2	11/26/25	ADD SCD RM-3.1

BRIDGE NO. CUY-77-15.46
IR 77 OVER WOODLAND AVE.

ESTIMATED QUANTITIES
BRIDGE NO. CUY-77-15.46
IR 77 OVER WOODLAND AVE.

GENERAL PLAN
BRIDGE NO. CUY-77-15.62
IR 77 OVER E. 22ND ST.

DRAINAGE PLAN
E. 22nd ST.

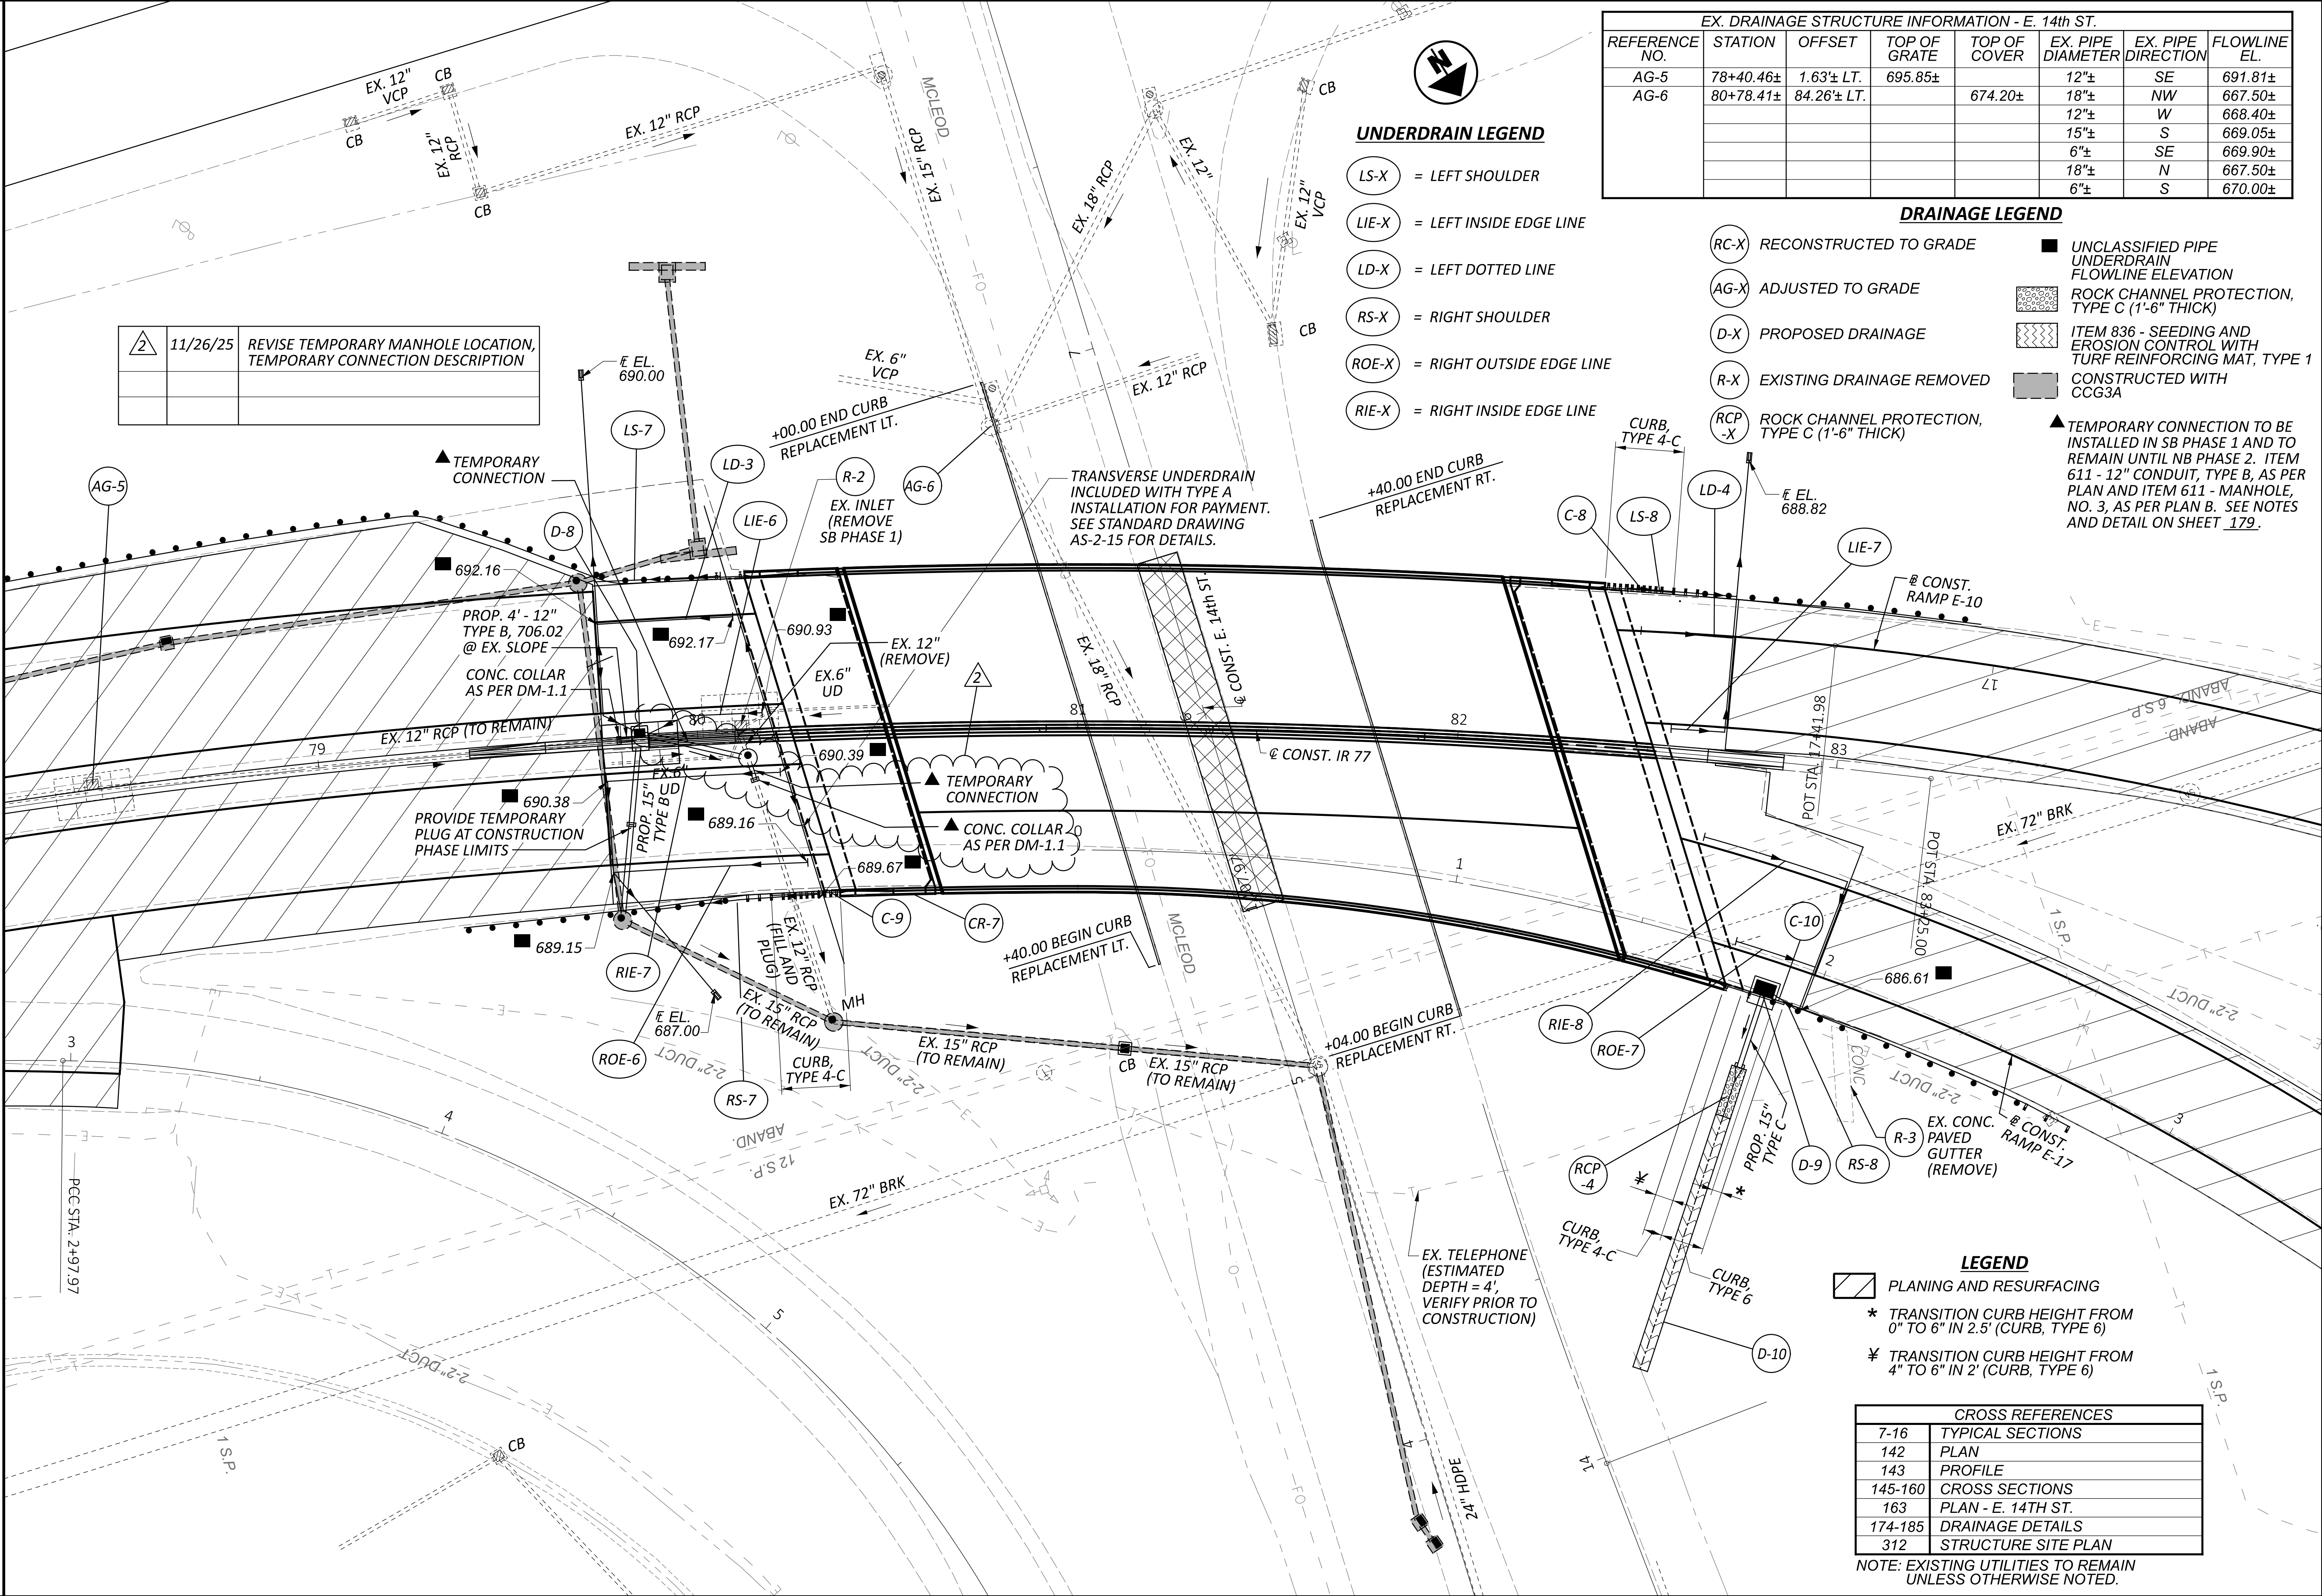
2	11/26/25	ADD CONCRETE SLOPE PROTECTION AT 22nd ST./ADD CONCRETE PATTERN

ITEM 611 – MANHOLE, NO. 3, AS PER PLAN B

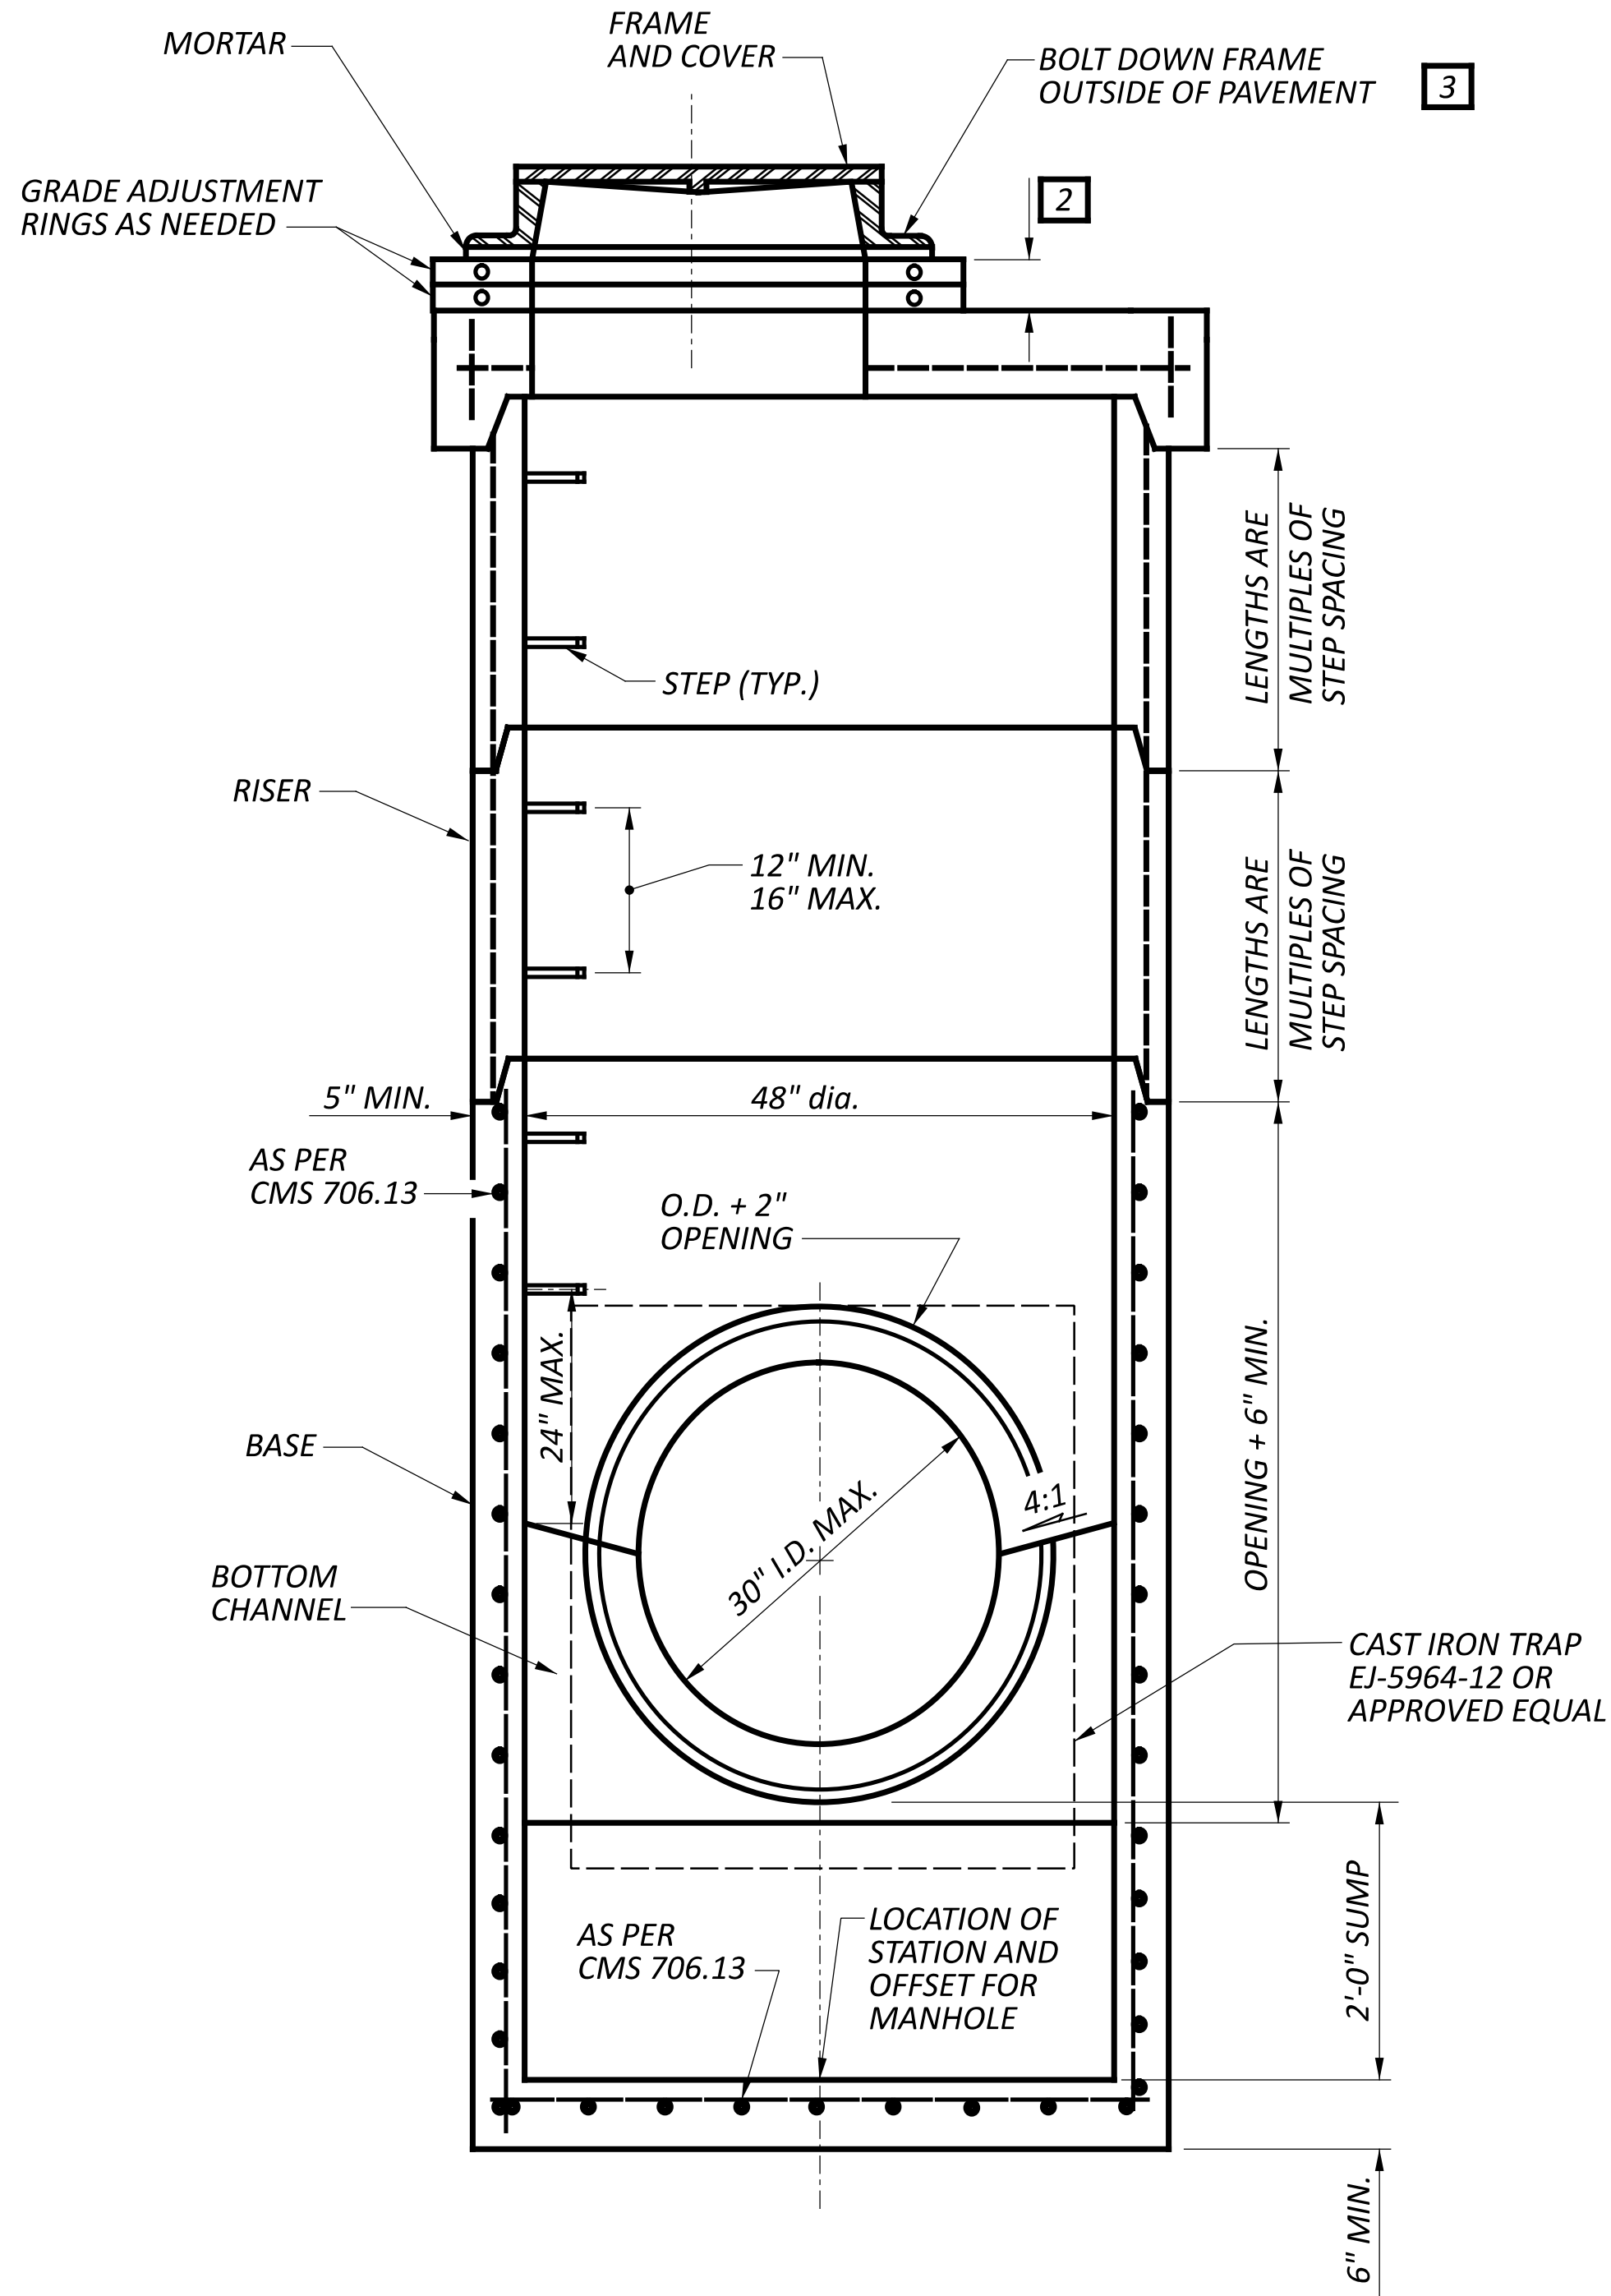
2	11/26/25	MOVE TEMPORARY MANHOLE,, REVISE ELEVATIONS, REVISE ITEM, REVISE QUANTITY

A TEMPORARY MANHOLE SHALL BE INSTALLED ALONG THE EXISTING 12” CONDUIT AT STATION 80+12.98, 5.84’ RT TO PROVIDE A TEMPORARY CONNECTION FROM THE PROPOSED INLET AT STATION 79+84.91, 2.65’ LT. THE TEMPORARY MANHOLE SHALL BE INSTALLED DURING SOUTHBOUND PHASE 1; THE TEMPORARY MANHOLE SHALL REMAIN IN SERVICE UNTIL NORTHBOUND PHASE 2. ONCE THE PROPOSED STORM SYSTEM IS FULLY INSTALLED AND ACTIVE, THE TEMPORARY MANHOLE SHALL BE REMOVED IN ACCORDANCE WITH CMS 202. SEE TEMPORARY CONNECTION DETAIL THIS SHEET.
